BLUE BIRD

R10RM

**SUBJECT: RECALL R10RM REAR INNER BULKHEAD PANELS FMVSS
221 JOINT STRENGTH NONCOMPLIANCE**

Rear Inner Bulkhead Panel Joint Strength Noncompliance

Street Side:

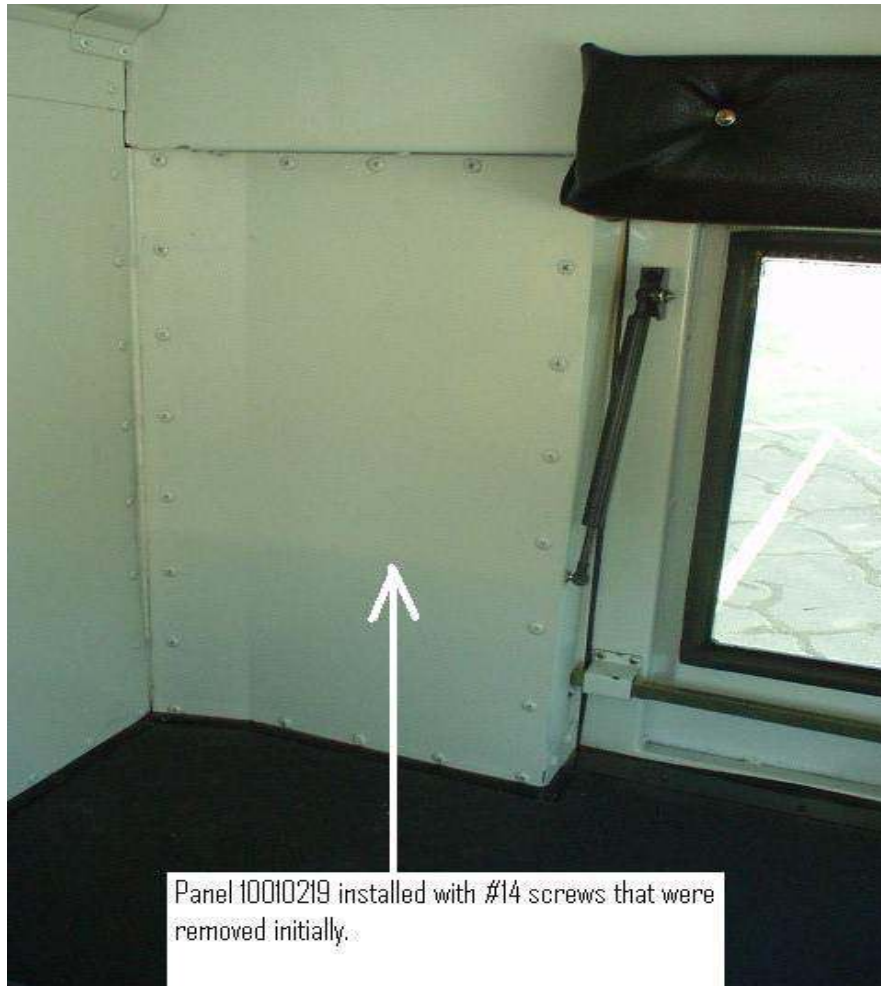
1. Remove panel without access panel and discard. Retain the screws. Sand the paint down to bare metal on the rear structure where the adhesive will be applied. Sand ½ inch on each side of screw holes. Be careful not to sand area that will not be covered by new panel. Wipe sanded area clean before installing adhesive.
2. Apply a ¼ inch bead of Magnabond adhesive in the center of the mating surfaces for the close-out panel along or near the screw line.
3. Install new panel (10015934) with #14 screws removed previously. Be sure to clean off any excess adhesive immediately before it has time to start curing.
4. Install access panel (10013015) with (6) 01164821 #10 x .75 screws.
